316 ANNANGROVE ROAD 2155 ROUSE HILL Lot 28 DP 834050

MIXED USE INDUSTRIAL DEVELOPMENT

No.	DESCRIPTION	DATE
01	PRELIMINARY FOR COORDINATION	2/02/2024

DRAWING TITLE:
LOWER GROUND FLOOR PLAN

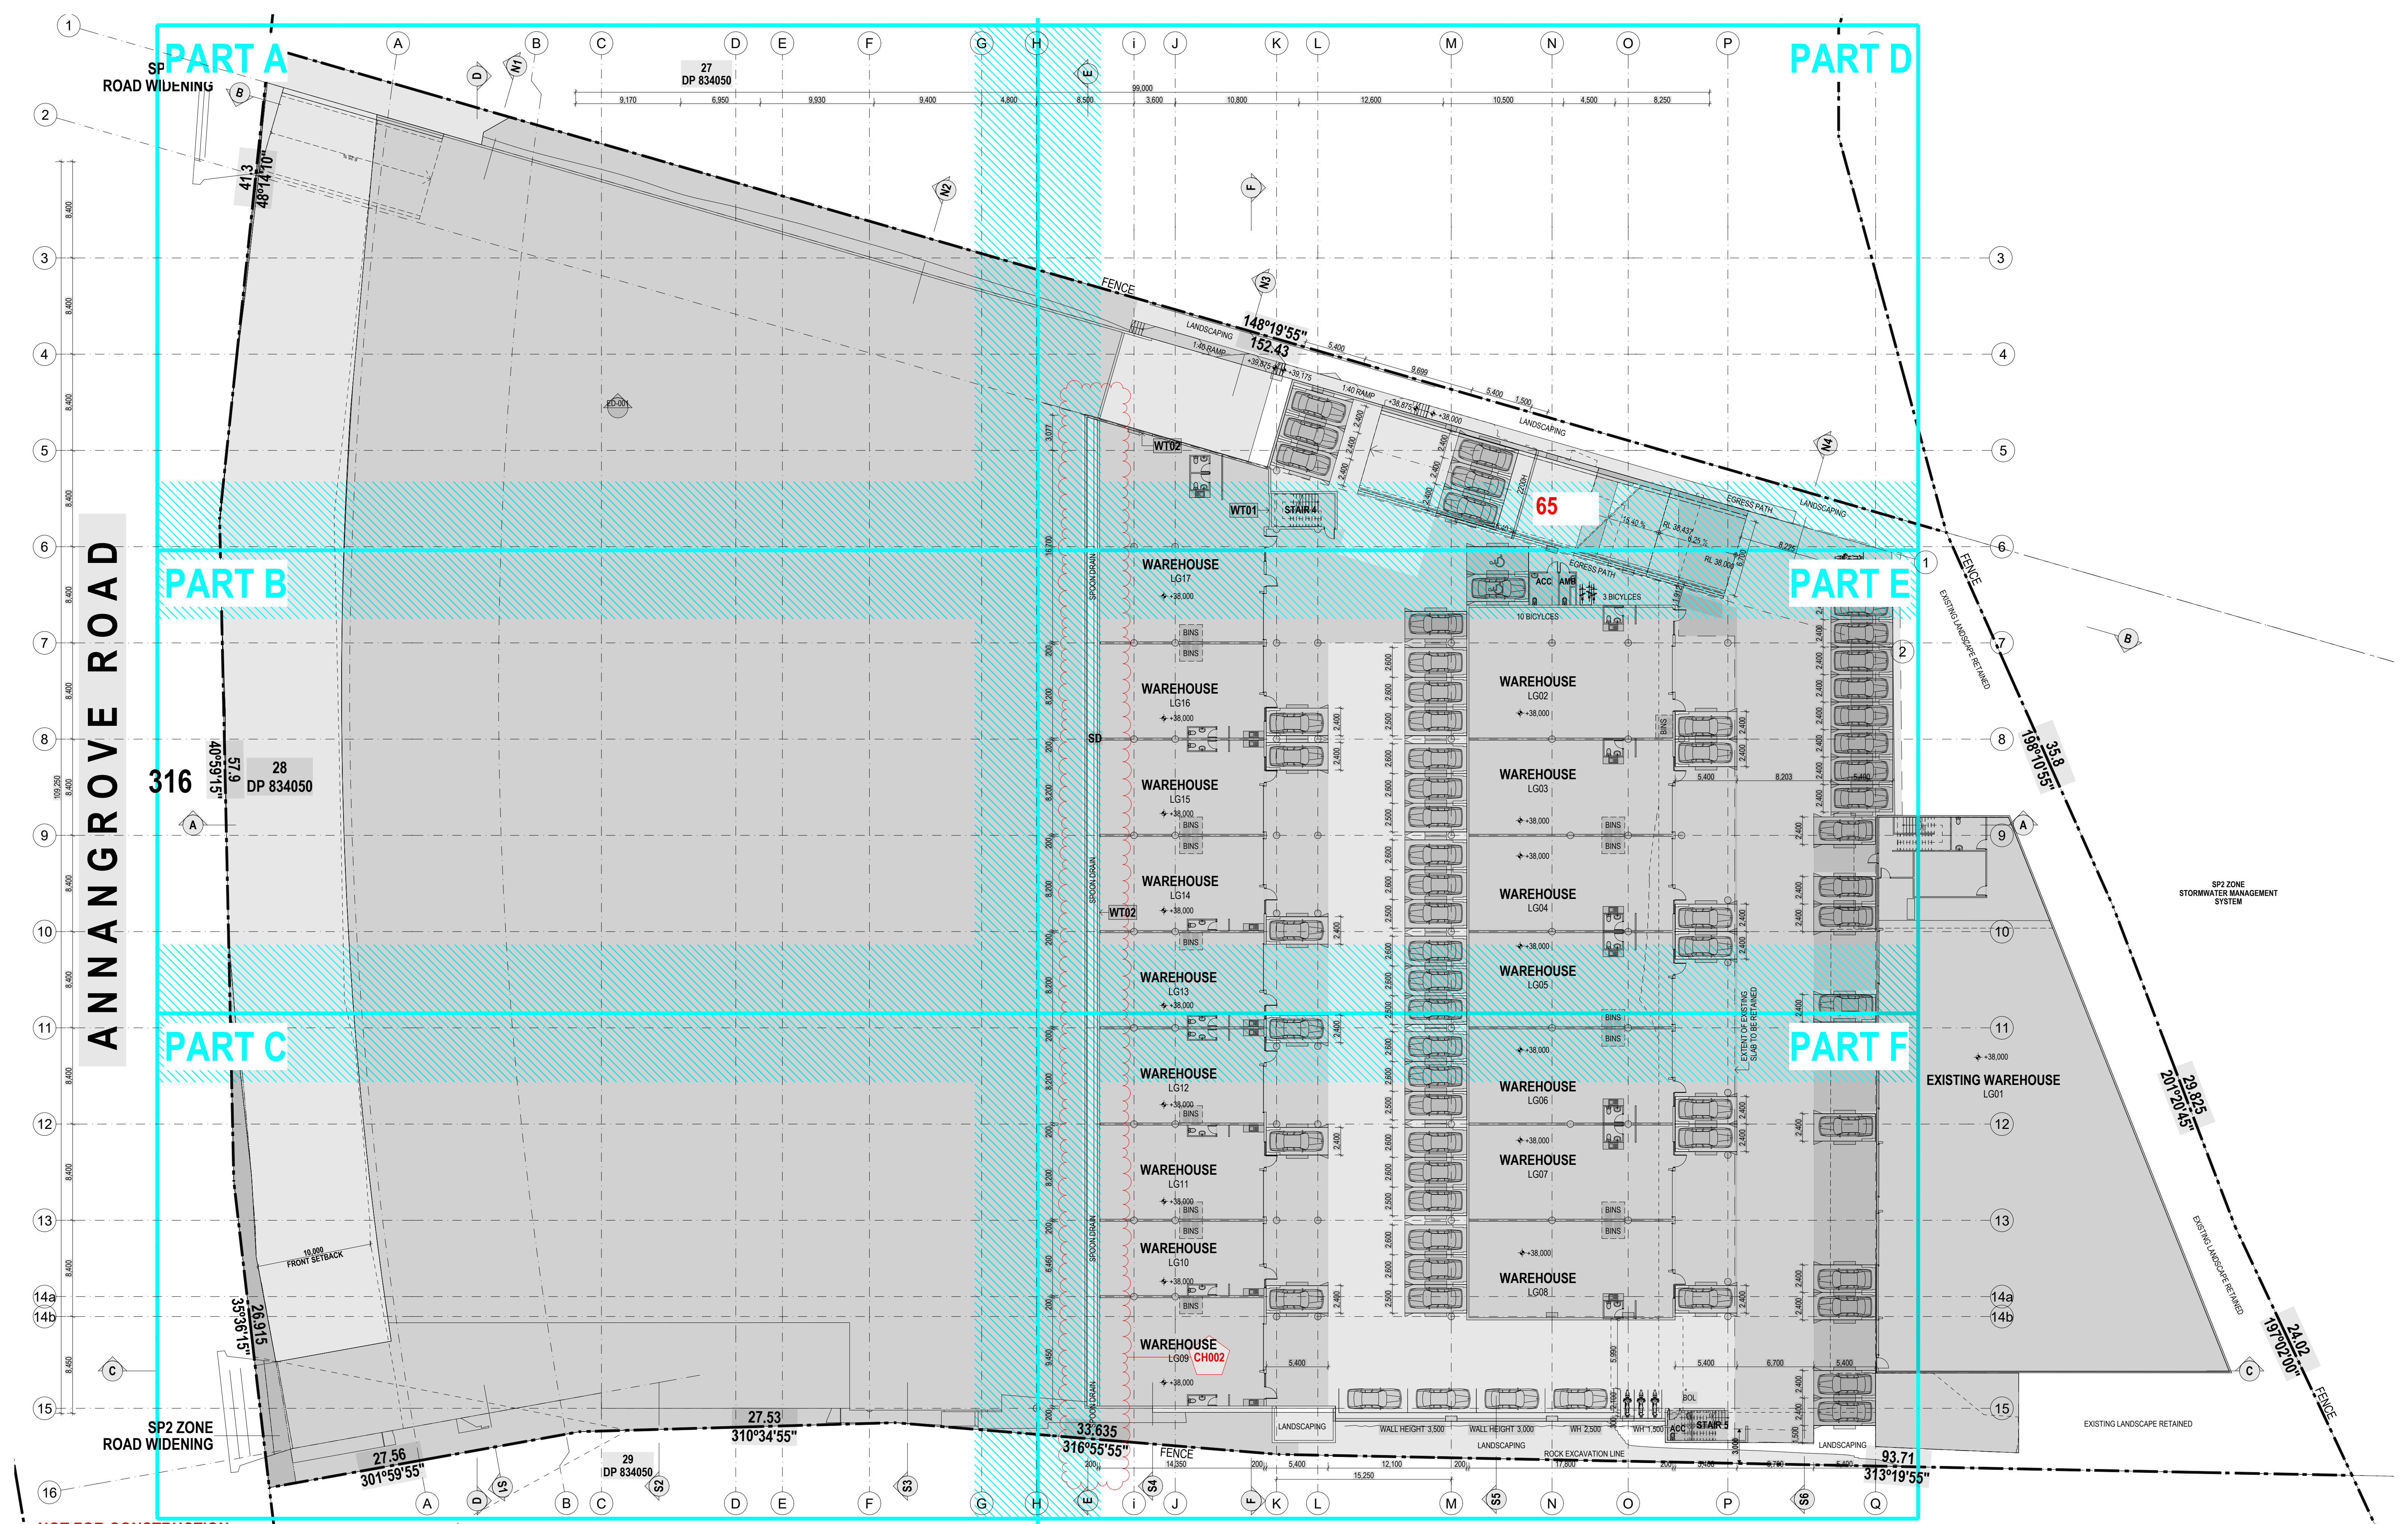
- CHANGES
- CH002 RETAINING WALL ADDED (OPENINGS - CONFINED SP, DRAINAGE, VENTILLATION, TBC)
 - CH014 AREAS REMOVED FROM PLANS

DRAWING TITLE:
GROUND FLOOR PLAN

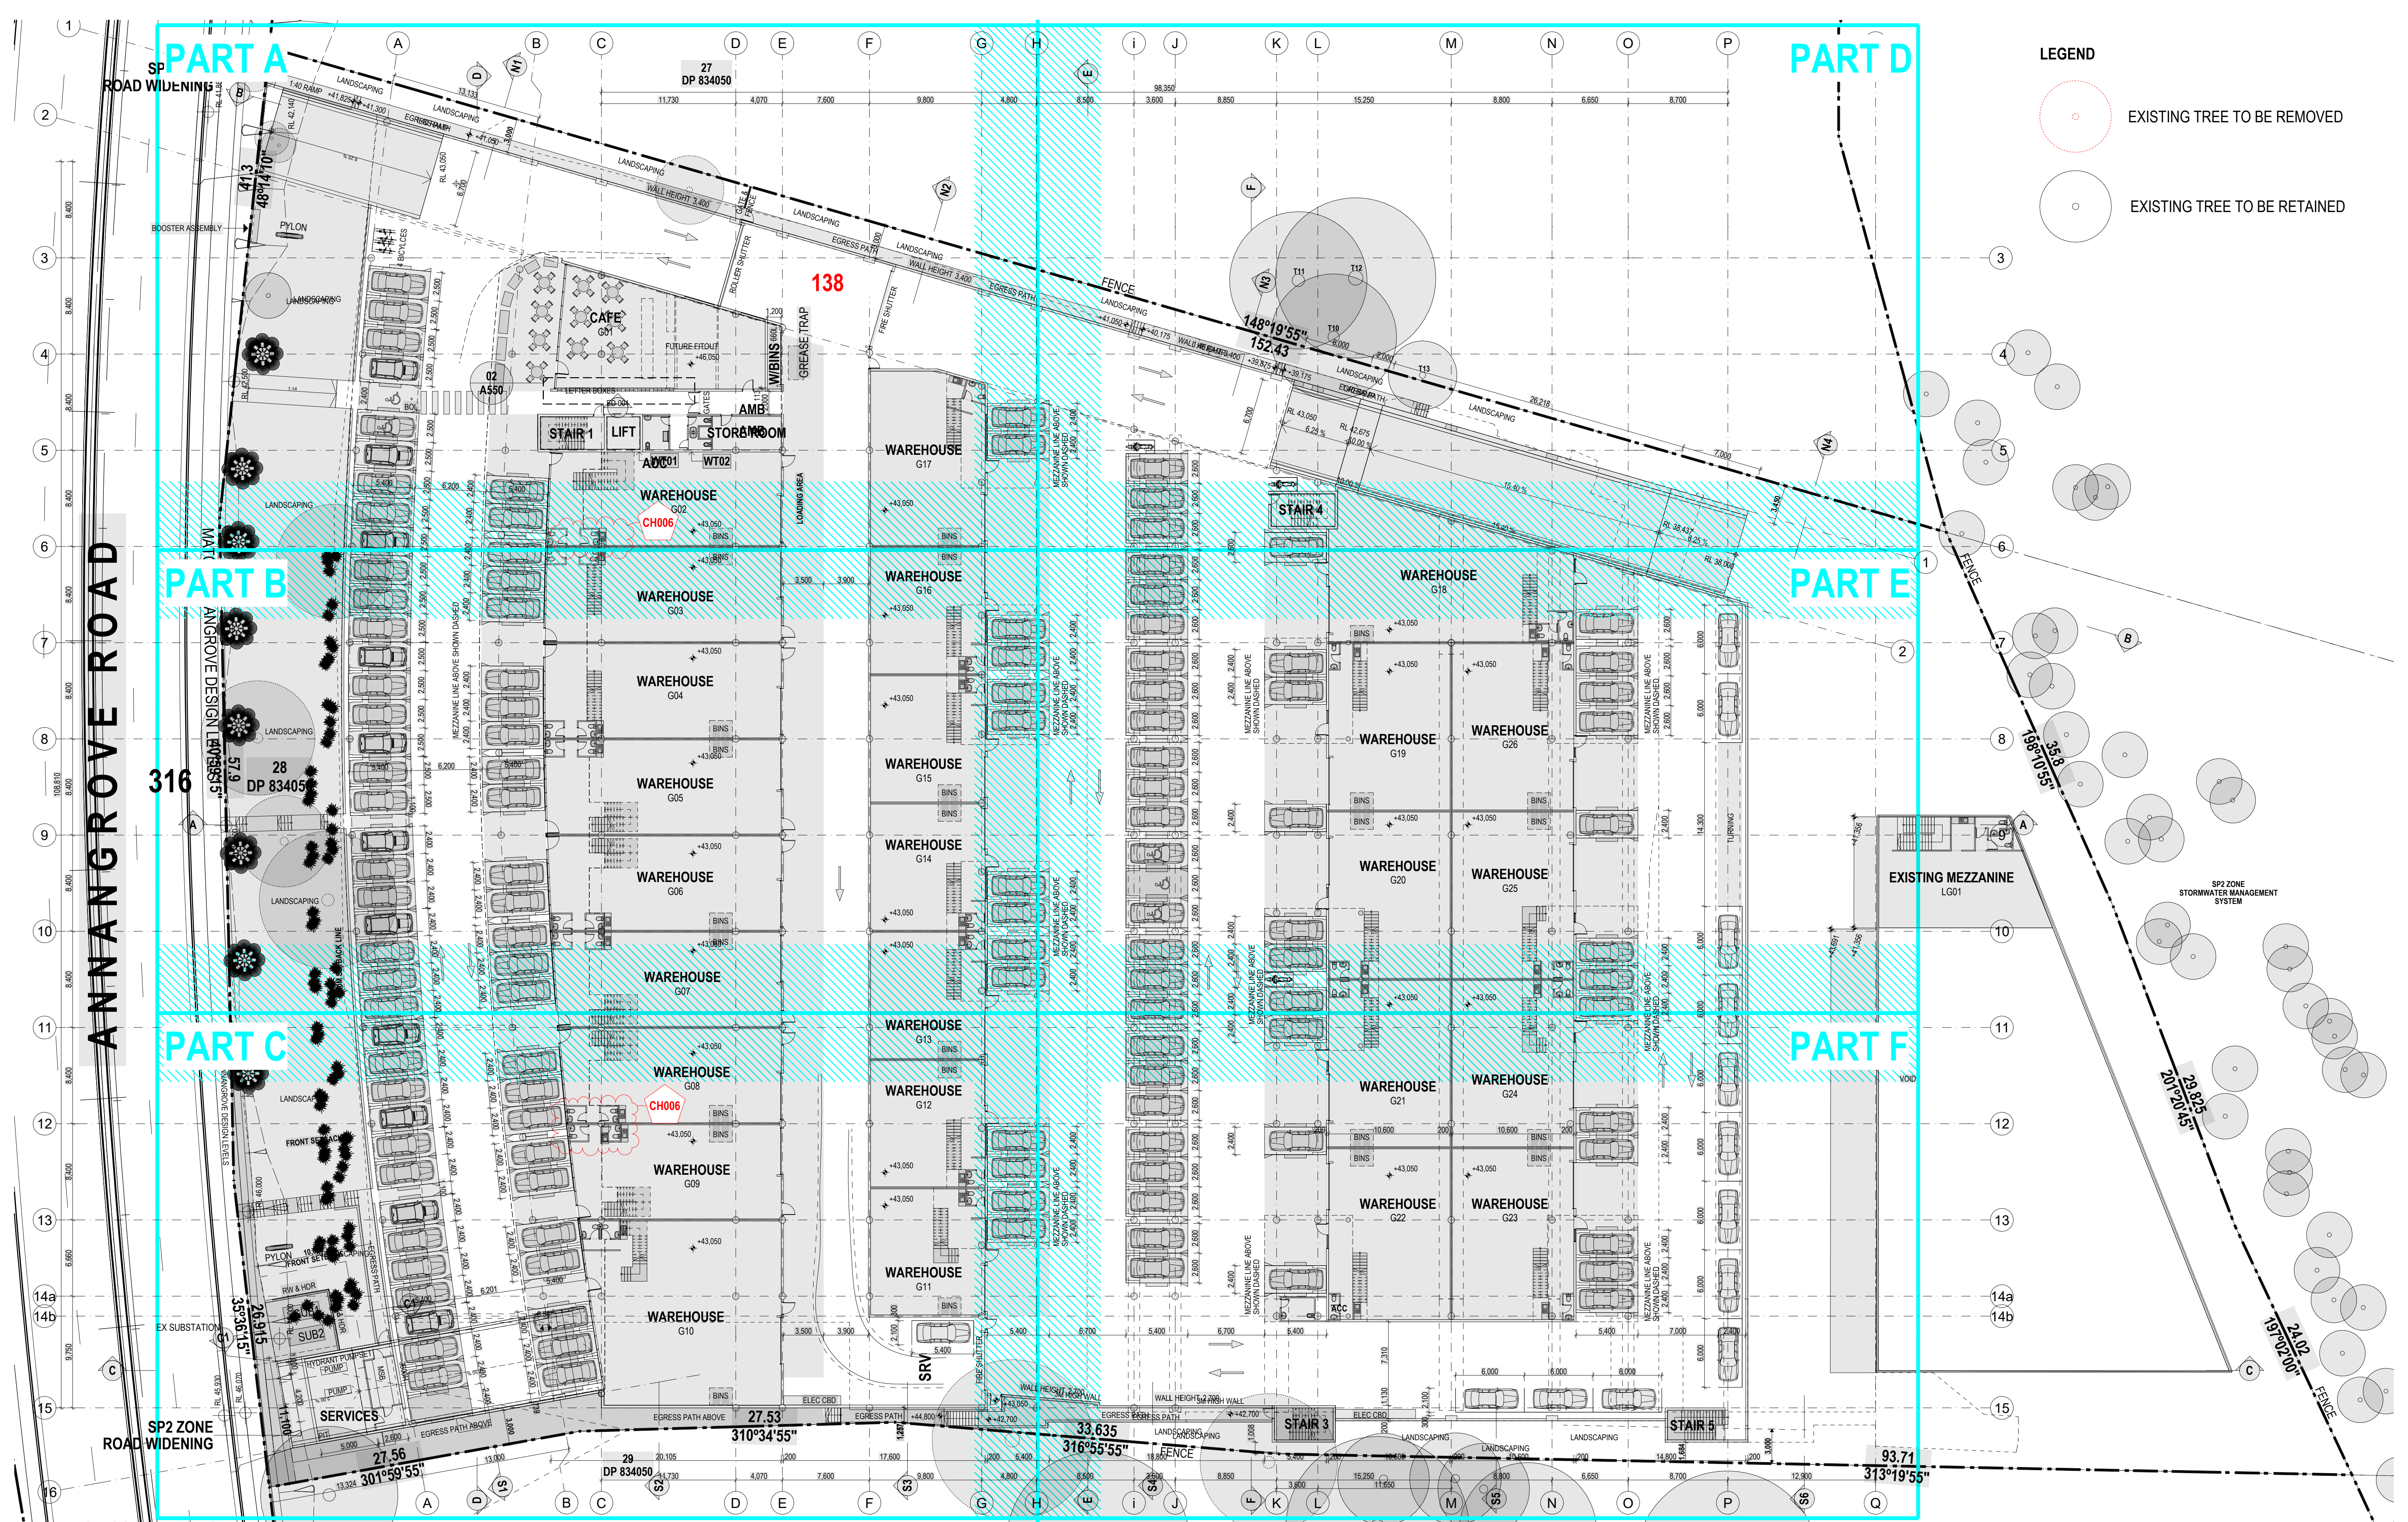
No. 01	DESCRIPTION PRELIMINARY FOR COORDINATION	DATE 2/02/2024	CIVIL ENG. ####	GEOTECHNICAL ENG. ####	MECHANICAL ENG. ####	LANDSCAPE ####	CHANGES CH006 TOILET ADDED TO WH8 & WH9, WH2 tbc CH014 AREAS REMOVED FROM PLANS
####	ELECTRICAL ENG.	####	HYDRAULIC ENG.	####	STRUCTURAL ENG.	PCA	####

DRAWING TITLE:
FIRST FLOOR PLAN

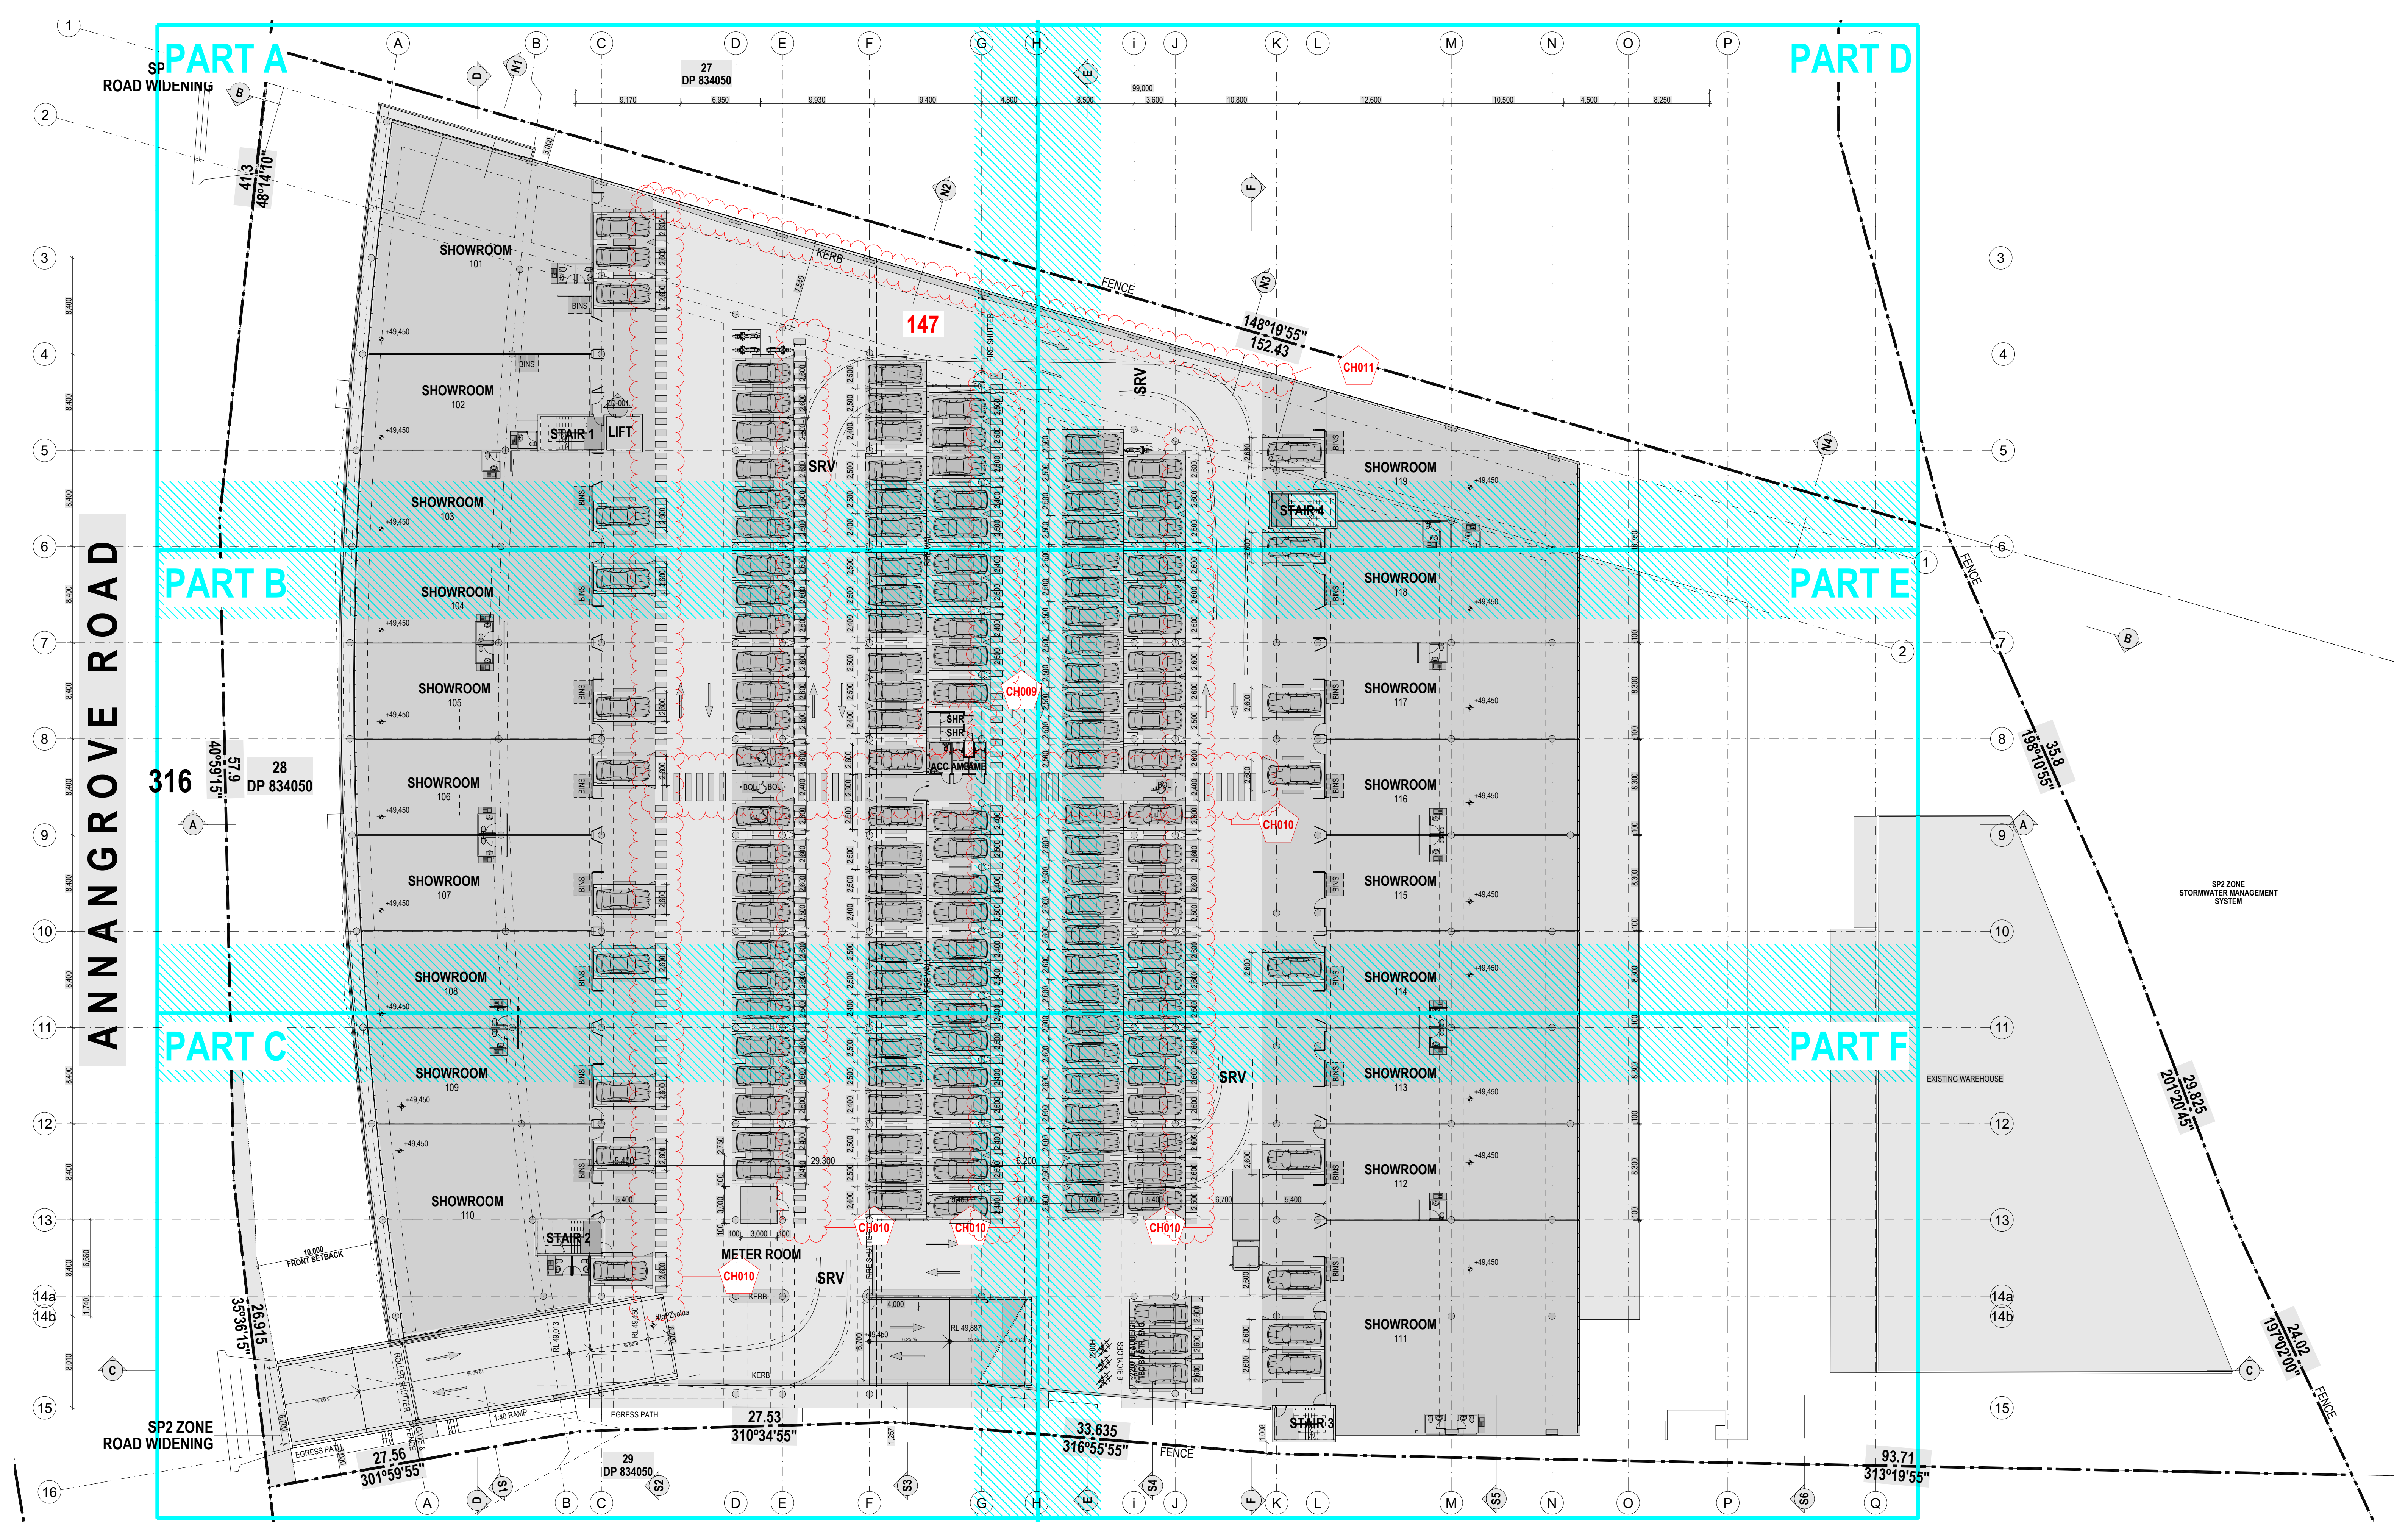
- CHANGES
- CH009 SHOWER LAYOUT AMENDED
 - CH010 ZEBRACROSSING/ PEDESTRIAN AREA ADDED
 - CH011 KERB ADDED
 - CH014 AREAS REMOVED FROM PLANS
